Access Compliance Report

Public Rights-of-Way

(Curb Ramps)

Intersection ID: 23191	Main Street: ALEXANDER_RD	Cross Street: IRONKETTLE_RD	Location:	E
ADA ID: B0853B617427	Ramp Type: Perp	Initial Pass/Fail: Fail	Overall Compliance: No	Severity Score: 12.5
Codes/Mitigation Info/Possible Solution		Field Measurements/Component Compliance

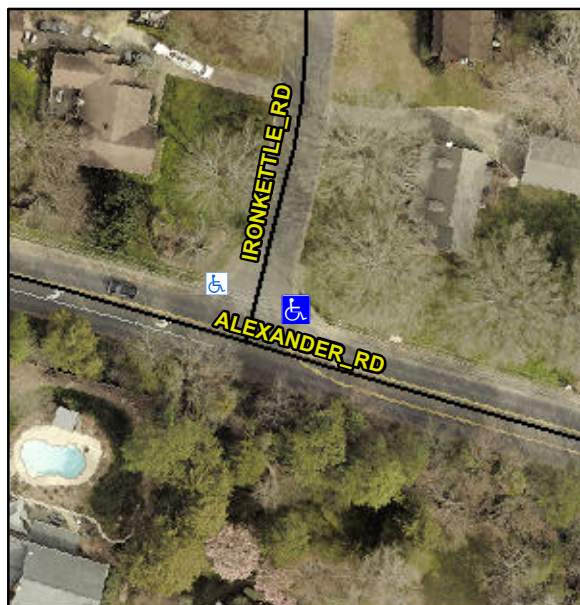
Not Found, R304.2.2

Compliance	Description	Data	Compliance	Description	Data
N/A	Ramp Length (in)	49.0	No	Ramp Slope (%)	10.6
Yes	Ramp Width (in)	48.0	Yes	Ramp XSlope (%)	1.9
N/A	Flare Type LT	N/A	N/A	Flare Type RT	N/A
N/A	Flare Slope LT (%)	N/A	N/A	Flare Slope RT (%)	N/A
N/A	Flare Traversable LT?	N/A	N/A	Flare Traversable RT?	N/A
N/A	Landing Length (in)	N/A	N/A	DWS Provided?	N/A
N/A	Landing Width (in)	N/A	N/A	DWS Contrast?	N/A
N/A	Landing Slope (%)	N/A	N/A	DWS Length (in)	N/A
N/A	Landing X Slope (%)	N/A	N/A	DWS Full Width?	N/A
N/A	Landing Curb? (Y/N)	N/A	N/A	DWS Offset (in)	N/A
N/A	Shared Landing?	N/A			
N/A	Gutter Ponding?	N/A	N/A	Gutter Slope (%)	N/A
N/A	Gutter Lip Ht (in)	N/A	N/A	Gutter X Slope (%)	N/A
N/A	Painted X Walk1?	No	N/A	Painted X Walk2?	N/A
	X Walk 1 Direction	To NW		X Walk 2 Direction	N/A
N/A	X Walk 1 Width (in)	N/A	N/A	X Walk 2 Width (in)	N/A
	X Walk 1 Slope (%)	4.6		X Walk 2 Slope (%)	N/A
	X Walk 1 X Slope (%)	3.4		X Walk 2 X Slope (%)	N/A

Remove & Replace Entire Ramp.
